July 8, 2025

**CN-296 NJSEA FIREHOUSE GARAGE
ADDITIONS AND RENOVATION**

ADDENDUM No. 1

PROJECT NO.	SHEET NO.
5669	FP1.0

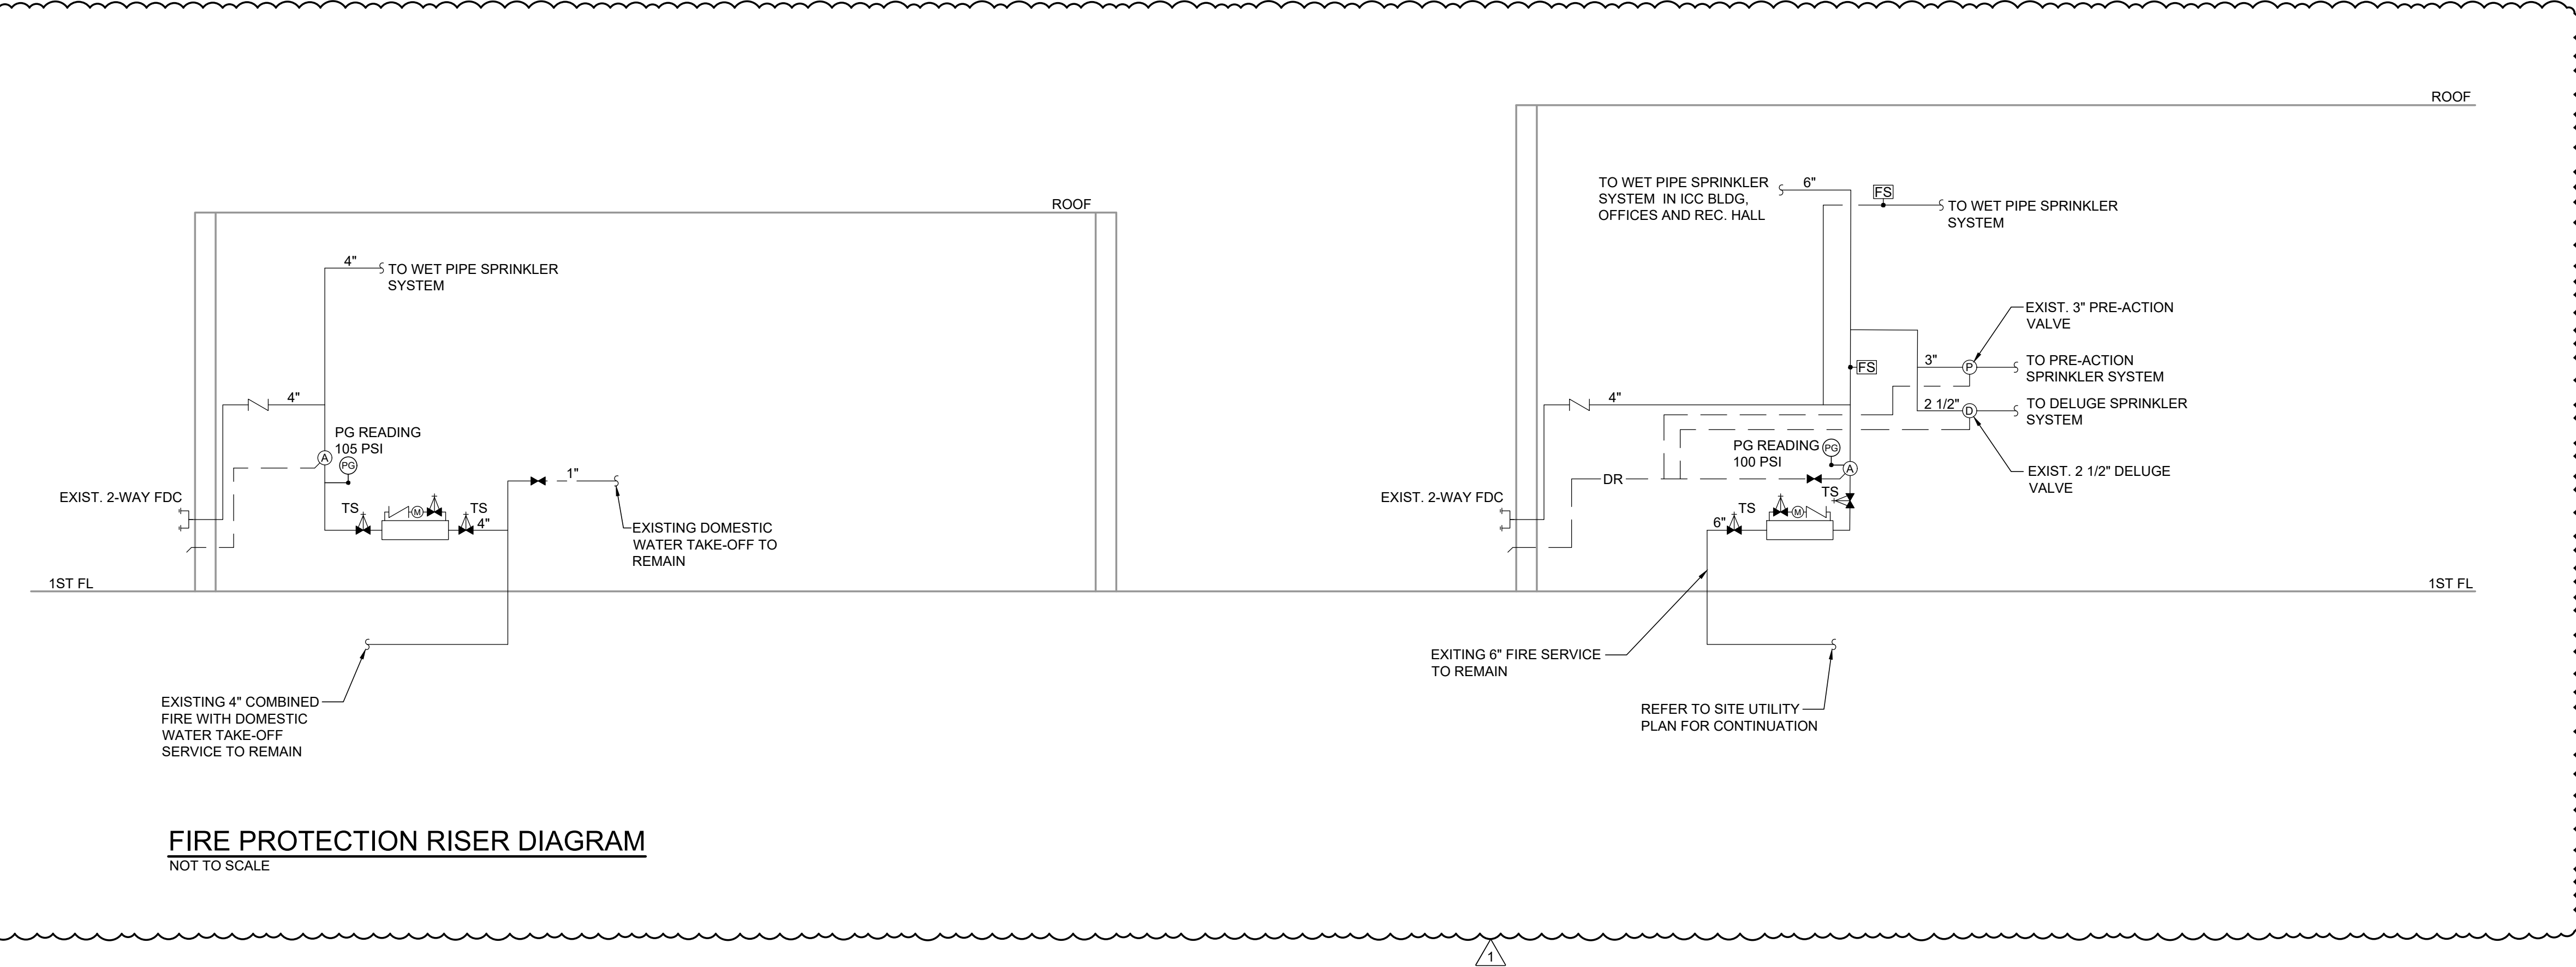
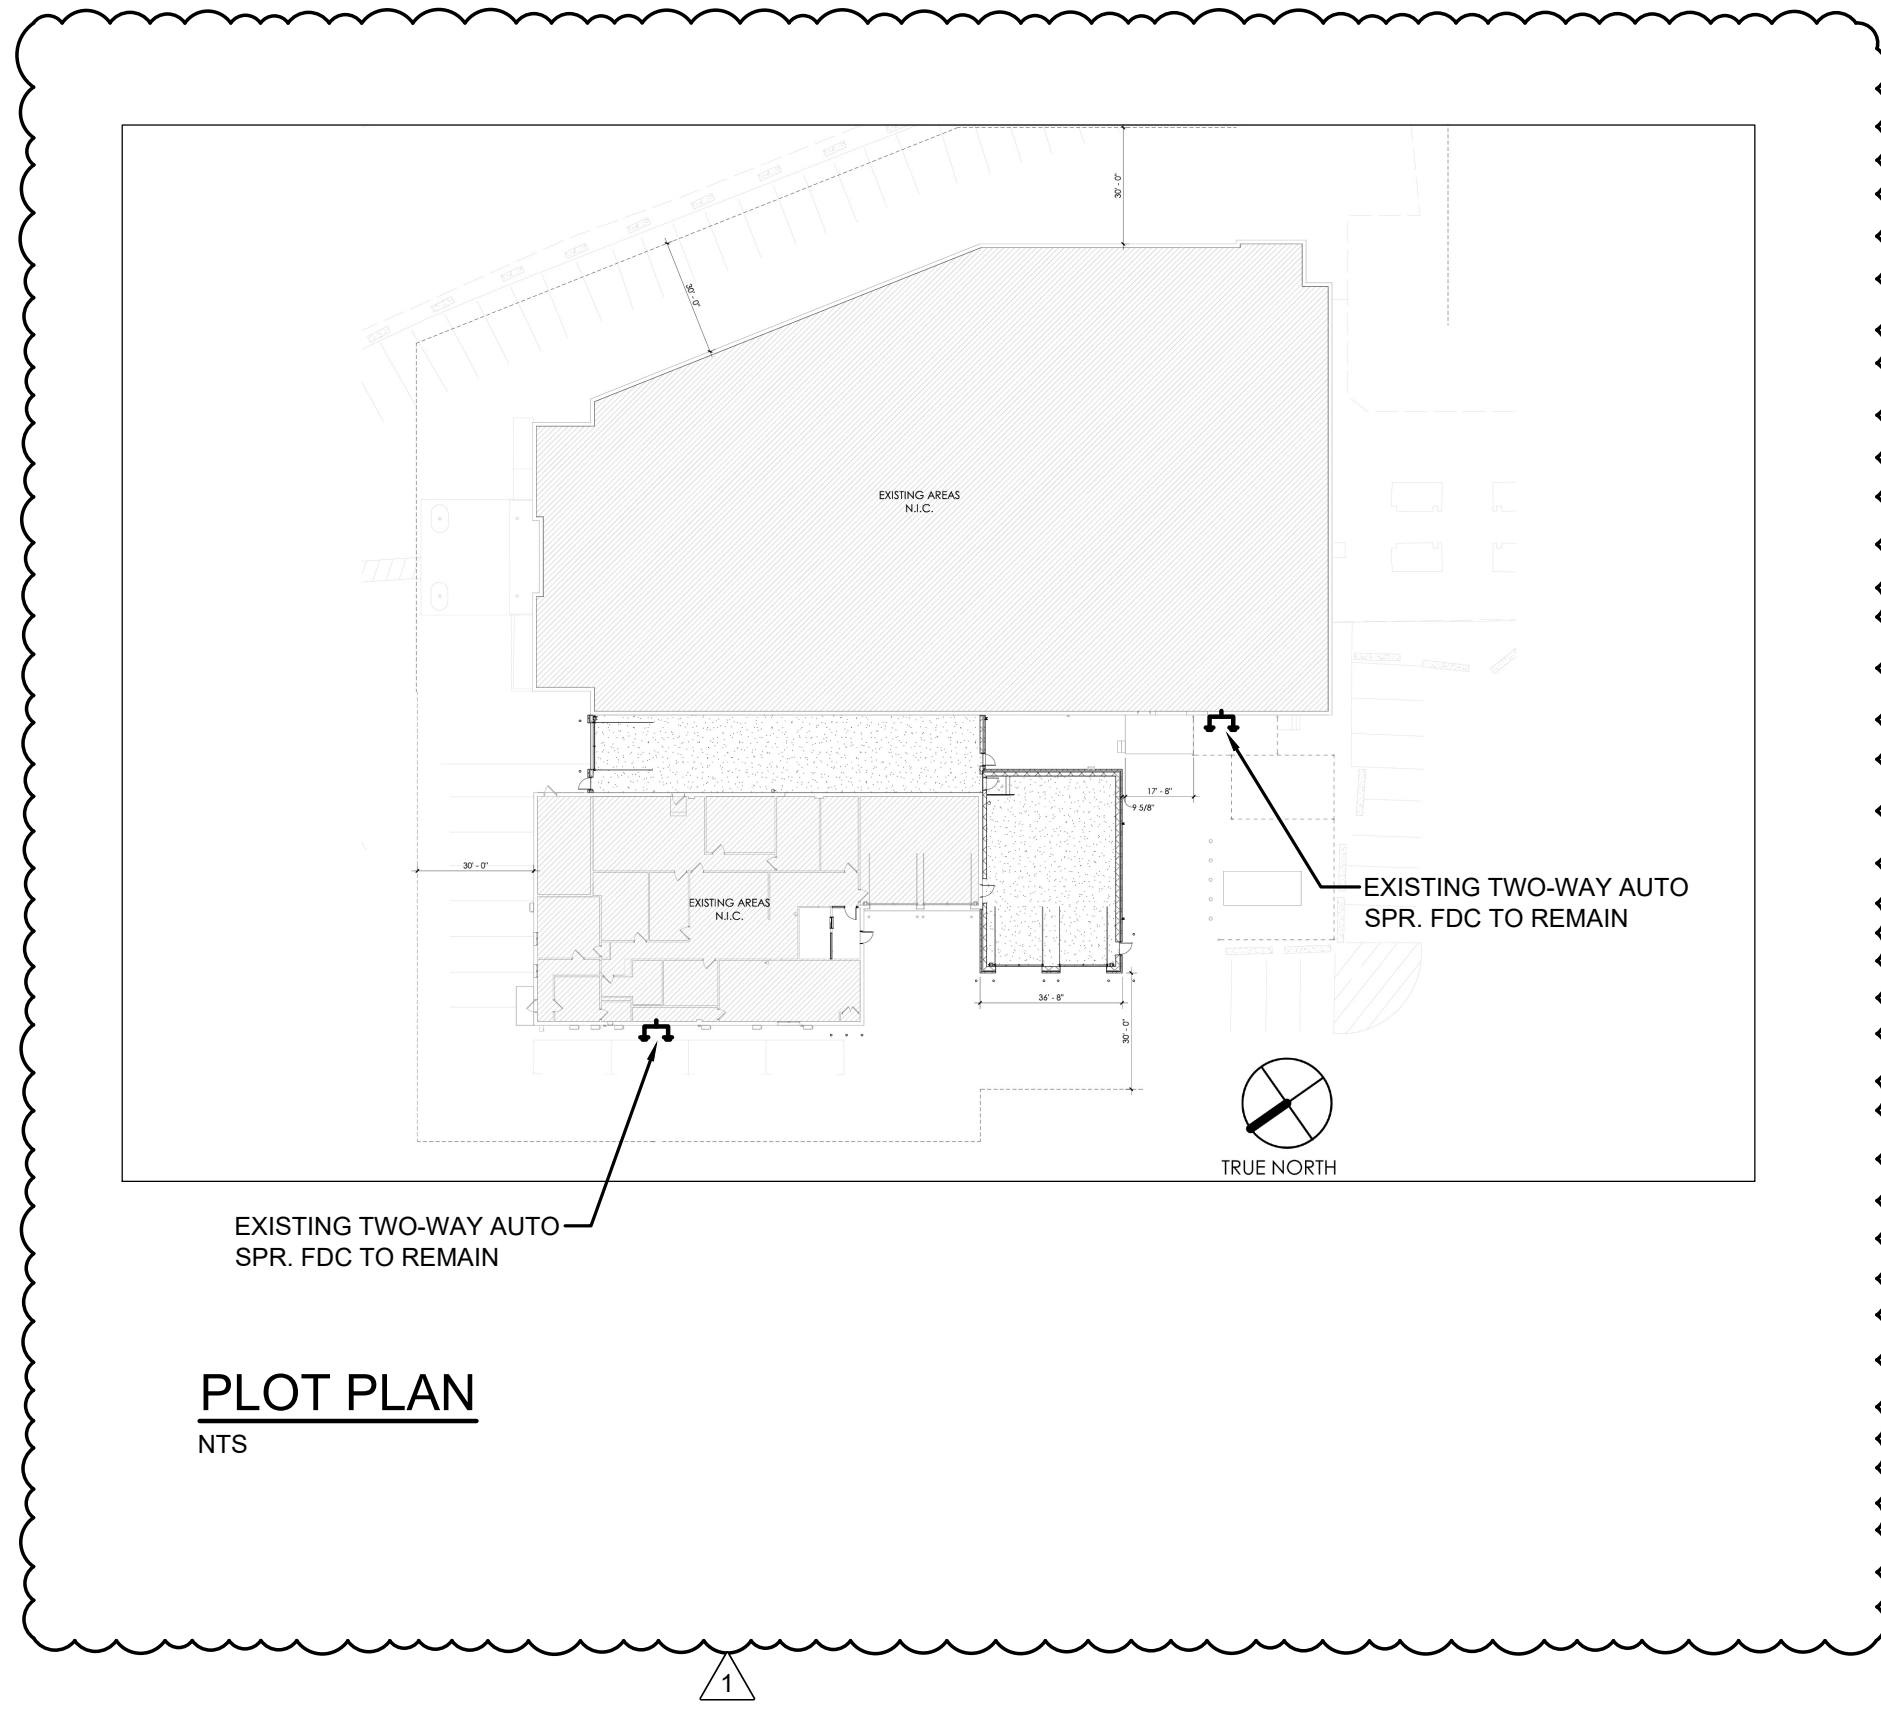
REV	DATE	DESCRIPTION
1	6/28/2025	REVISED AS PER DCA COMMENTS
